<b>Subject:</b>  <b>BLOWER MOTOR STAYS ON AFTER KEY OFF</b>	<b>Bulletin No:</b> 07-003/11
	<b>Last Issued:</b> 05/26/2011

2007-2010 CX-9 built before JM3 TB\*\*\*\* A\* 227576 (May 17, 2010)

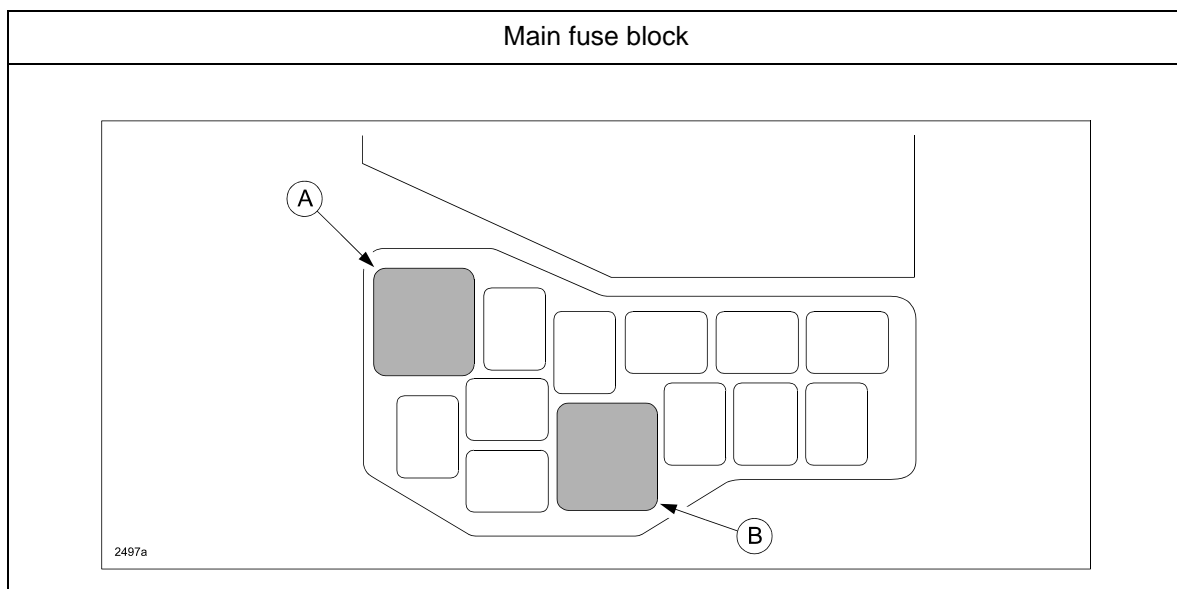
If customer complains about an intermittent front or rear blower motor operation after ignition key is switched to the off position, replace both front (A) and rear (B) blower motor relays.

Part Number	Description	Qty.
L1Y1-67-730	Blower Motor Relay	2
